MULTNOMAH COUNTY
TRANSPORTATION DIVISION

FOR PERMIT SUBMITTAL; NOT FOR CONSTRUCTION

SPRINGVILLE RESIDENTIAL

C-701

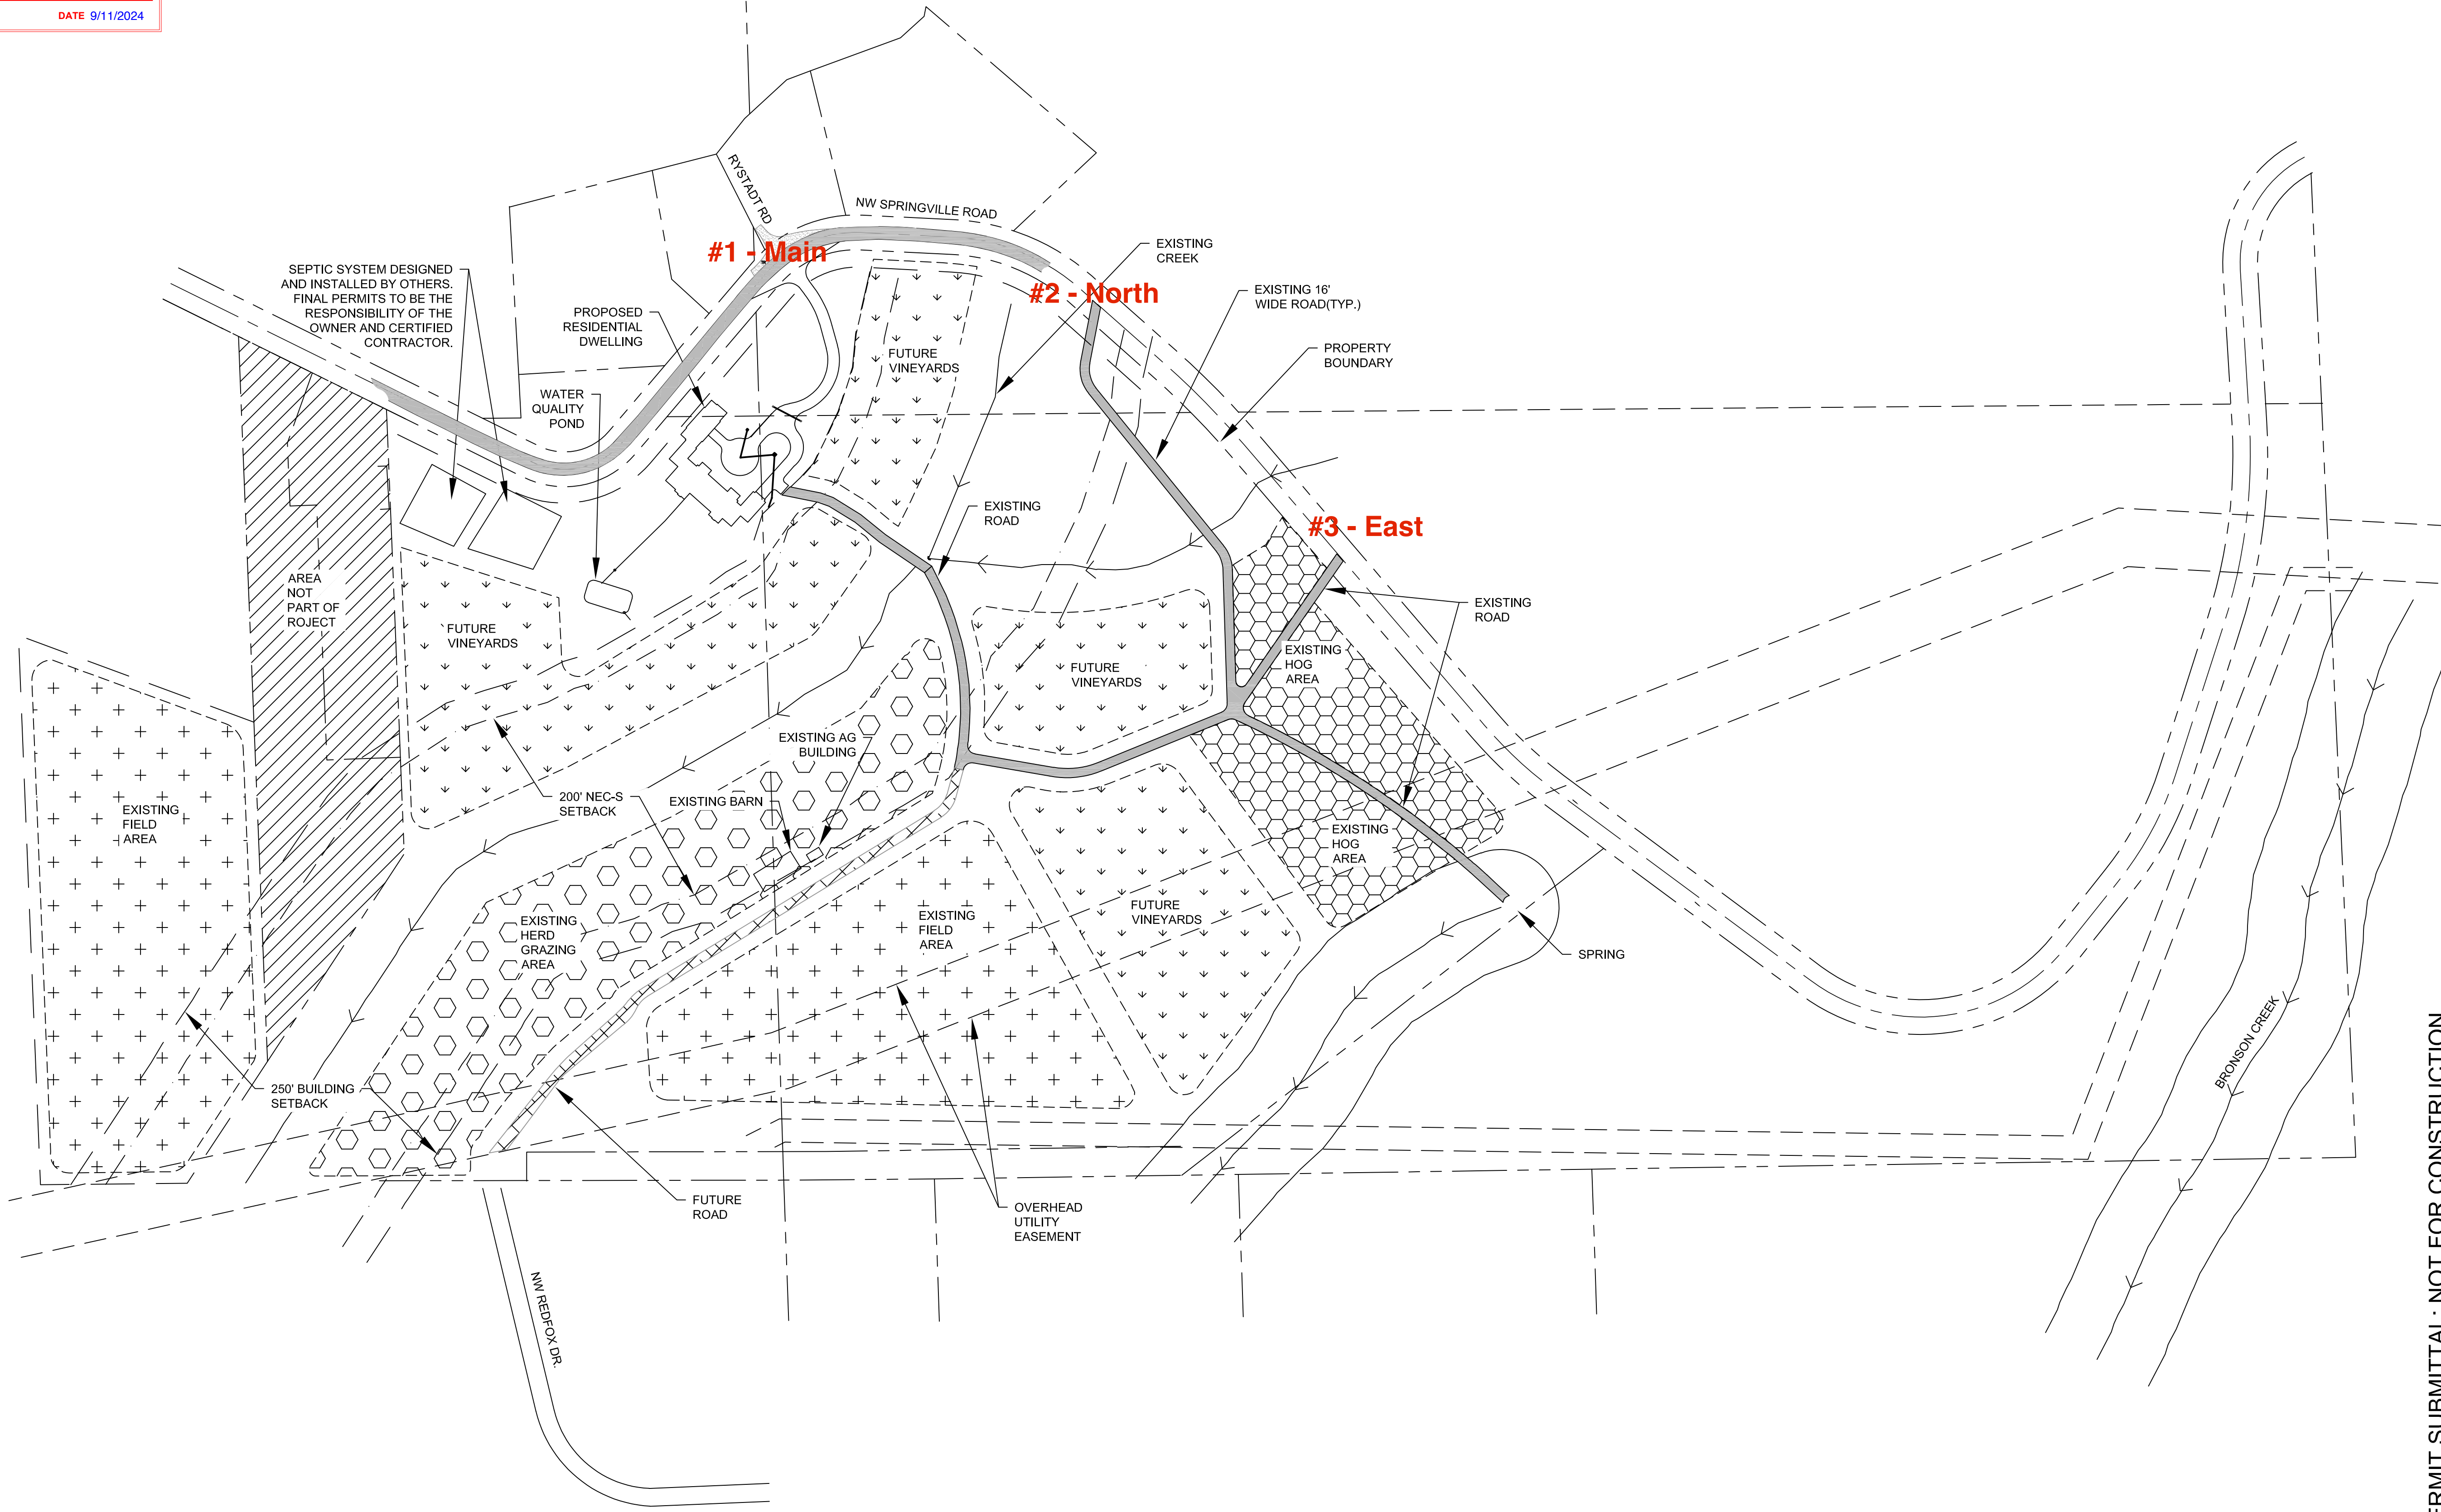
☒ APPROVED AS NOTED
